Item No. 10

Date: 06-17-21

Clarksburg Elementary School #9, Mandatory Referral, MR2021006

Staff Recommendation: **Denial**

Figure 3: Proposed Site Layout

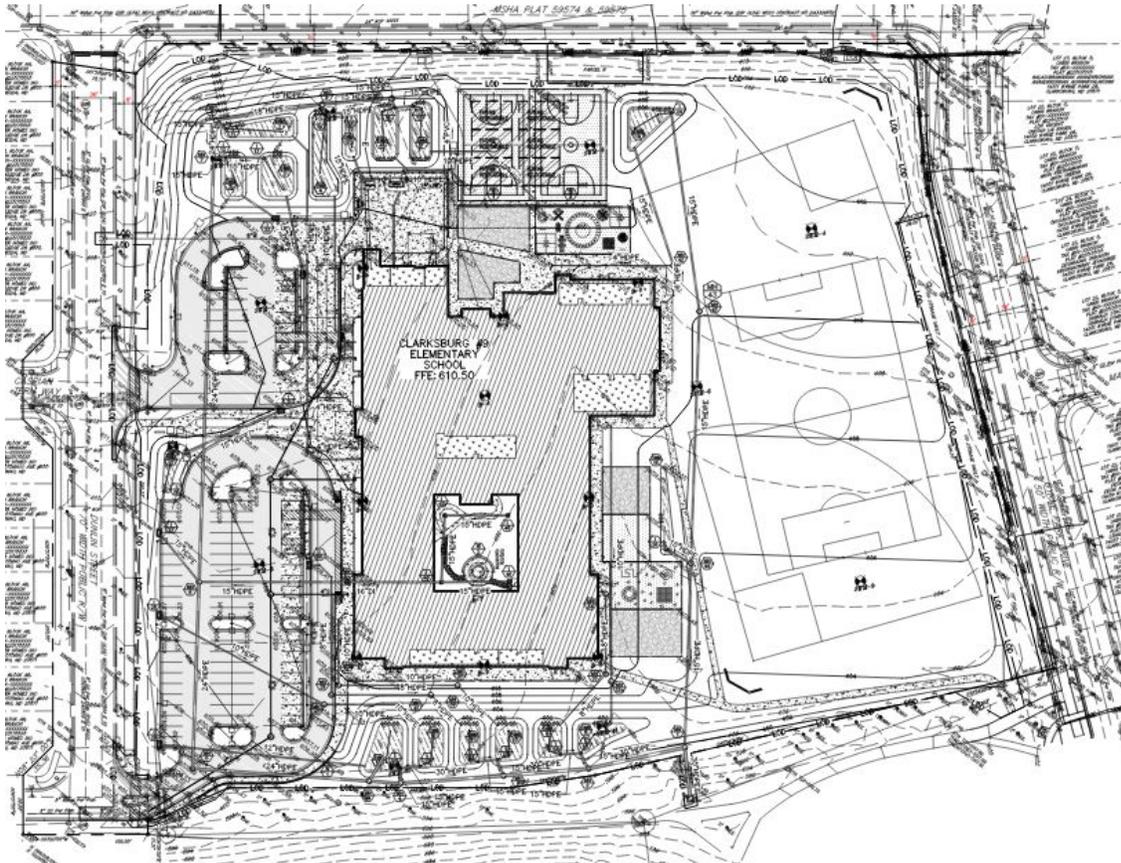
New school buildings should be sited in a manner that addresses adjacent streets, promotes safe walking and biking to school, and provides a civic presence to their communities. An inviting plaza should lead from the main street frontage to the school entry. This is especially important in a new community, like Cabin Branch.

Two-thirds of the Cabin Branch residences are located northeast of Byrne Park Drive and the school site. However, the Clarksburg Elementary School is proposed to be located in the middle of the site southwest of Byrne Park Drive, approximately 14 feet below the Clarksburg Road street grade. Storm water management facilities, two basketball courts, and portions of the baseball/soccer field sit between Clarksburg Road and the side of the school. The primary school entrance is accessed from a narrow sidewalk sandwiched between two school parking lots on Dunlin Street. The rear of the school faces Byrne Park Drive and is separated from the street by the school's ball fields. There is limited pedestrian access to the school from this side of the site.

In order to achieve a better design relationship between the proposed Clarksburg Elementary School site and the surrounding community, the new school should be sited near the intersection of Clarksburg Road and Byrne Park Drive to engage the public realm and create a civic presence and gateway into the community. The main entrance to the school should be on Byrne Park Drive. A large plaza with shade trees would provide a welcoming pedestrian experience to the school. School parking and drop-off areas should not be the prominent feature in front of the school, but should be placed south of school between the school and Clarkmont Local Park. This will allow for shared-parking opportunities during non-school hours between the school and the park. Instead of scattering the play courts and ball fields around the perimeter of the school, a larger and cohesive activity area would be created with the school placed along the prominent corner of the site.

Applicant's Response: There are two parcels internal to the school site that are separately owned by Tri-Pointe Homes DC Metro Inc. that would preclude the fronting of the building on either Byrne Park Drive or Clarksburg Road (MD 121). This combined with elevation changes at this intersection and concerns of regrading the site might cause site specific concerns of soil stability and the ability to meet MCPS's timeline and budget constraints.

Figure 9: Master Plan Illustration on Mix of Uses (note the location of the school, fronted on major roadways and adjacent civic space)

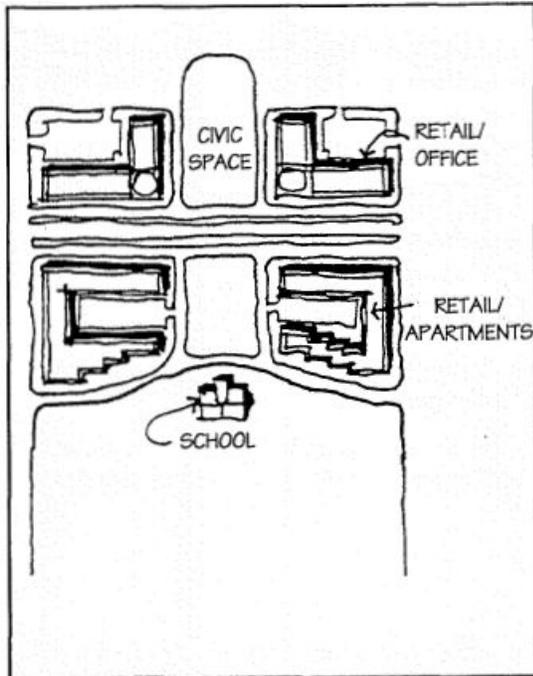
While the use is consistent with the Master Plan, the design choices made by MCPS make this application not in substantial conformance with the Master Plan. In this plan, the school is set back from the street in the middle of the larger site with expansive parking lots separating the school entrance from the public realm of the street. This separation degrades the public realm of the adjacent neighborhood and diminishes the safety of pedestrians and bikers coming to the school. Likewise, the intimate civic nature of the school is diminished in favor of a more suburban commercial building behind expansive parking lots. A thin walkway and entry plaza is created to try to mitigate the created problem. Also, in this plan, services including the garbage collection area are located along, and facing onto Clarksburg Road, one of the most prominent streets within this community. Although these uses are screened, they are still below the street elevation which possibly allows views into them from above. These uses must be located away from the public realm of streets, especially this most important street.

Figure 10: Master Plan Illustration for Street Oriented Design within the Cabin Branch Neighborhood

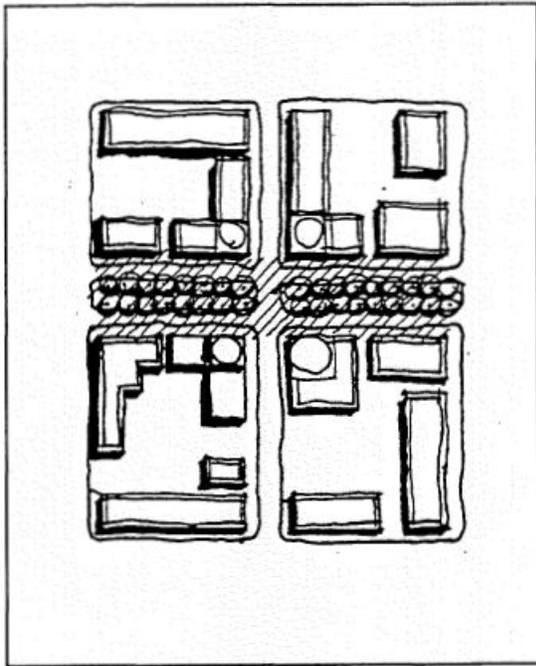
Again, in urban environments, buildings should frame streets and public spaces rather than float within sites surrounded by parking lots and services uses.

Figure 11: Vehicular Access Circulation

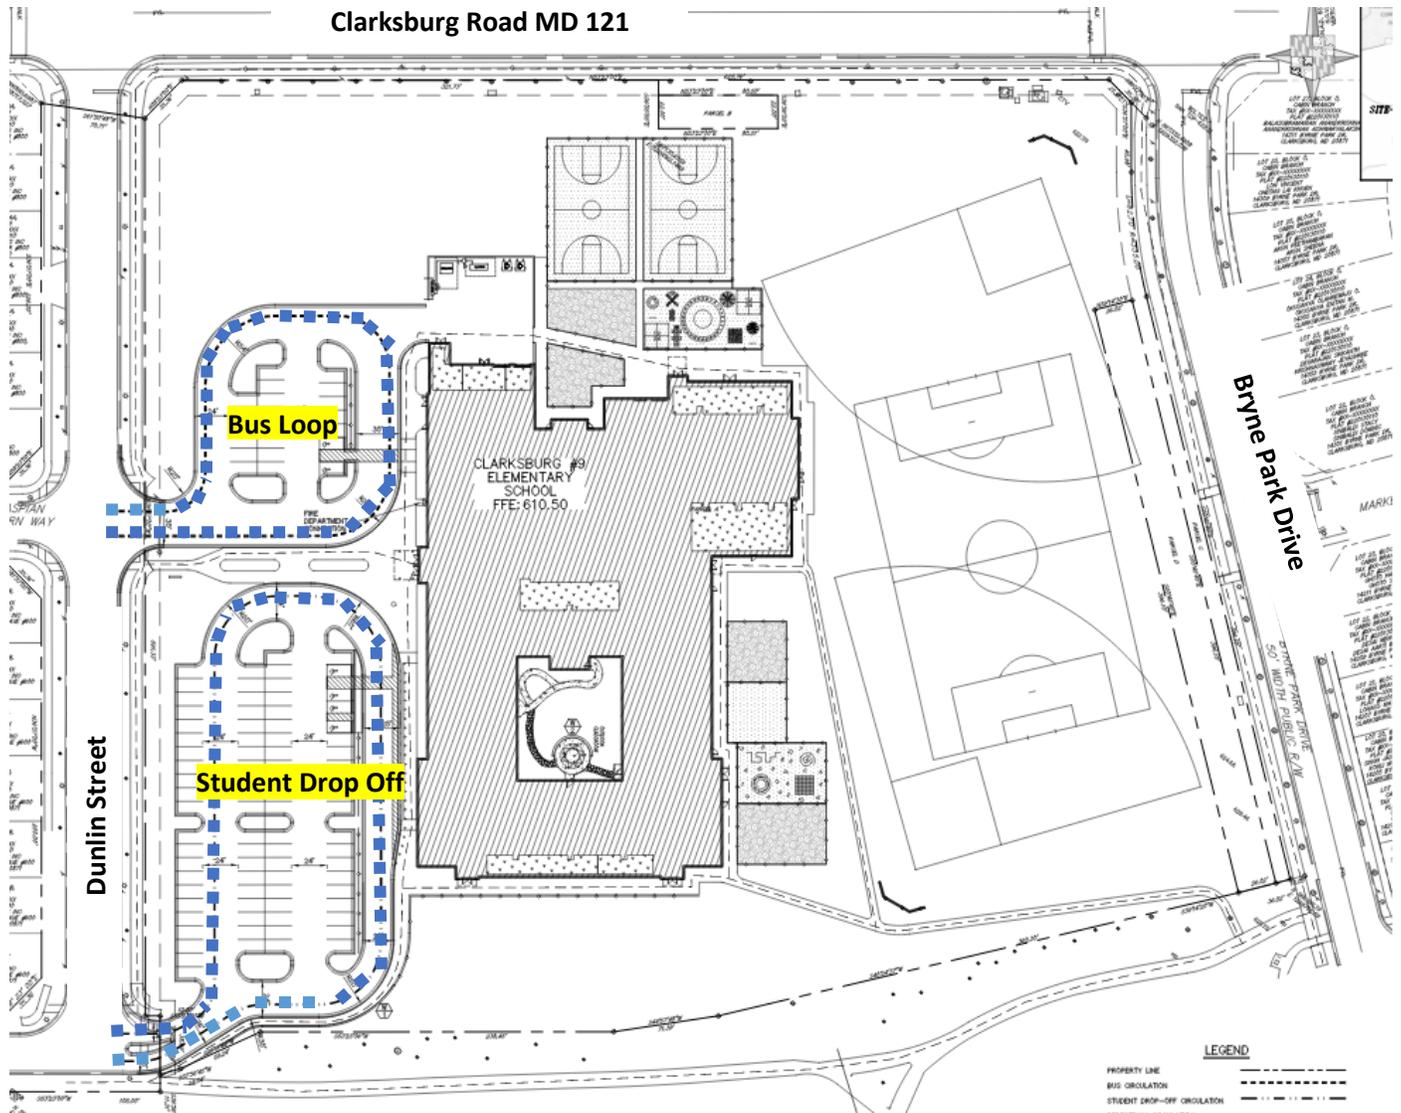
Staff parking along with a student drop-off loop will be accessed from Dunlin Street along the southwest side of the Site and will provide access to the main entrance of the building. Visitor parking along with a bus drop-off loop will also be accessed from Dunlin Street along the northwest side of the Site. Parking for the proposed site will be provided via surface parking to accommodate 90 vehicles including 4 ADA parking spaces. The proposed circulation and parking does not support the public realm and the current bicycle infrastructure it has to offer. The proposed configuration of the school site also does not define the streets as well as provide a sense of safety and urban design appeal to the public.
